# URBAN DESIGN COMMISSION

## DESIGN REVIEW RECOMMENDATION

### 599 Somerville Ave

August 6, 2021

## Façade Evolution

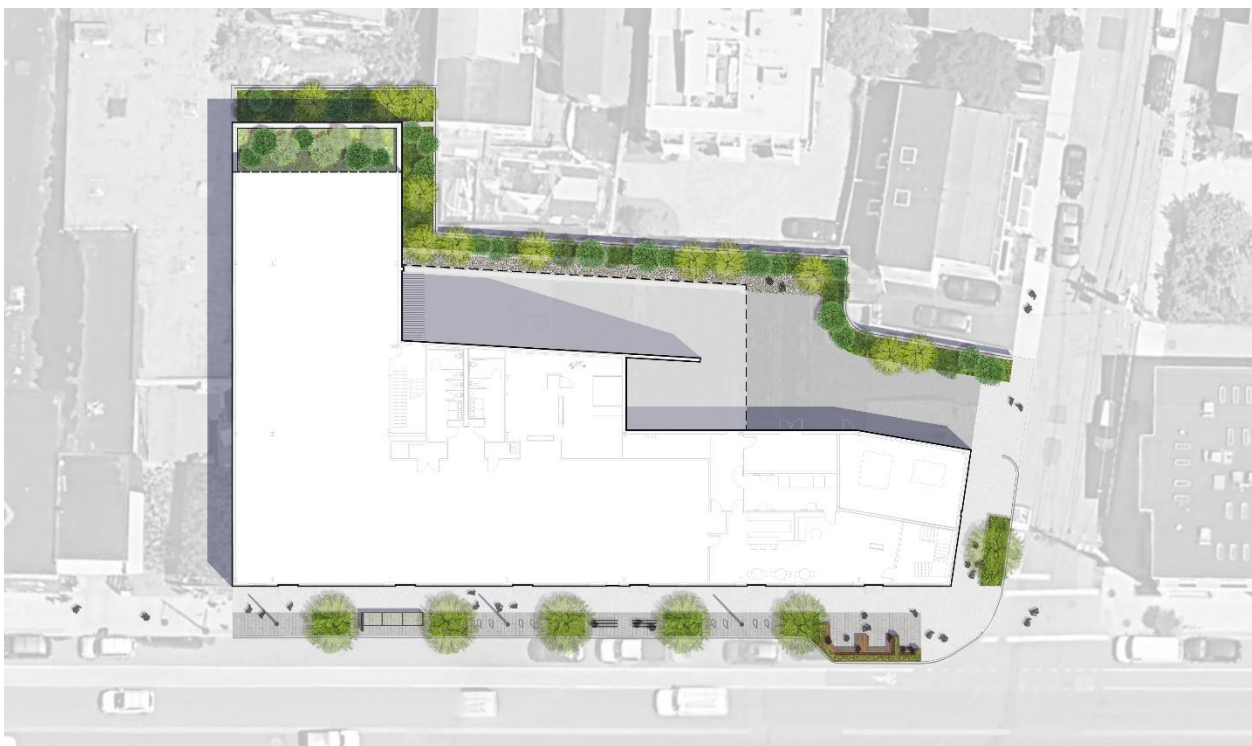
**Further Exploration  
“Celebration” of right corner of building**

**REMAING CONCERN  
Rear Landscaping**
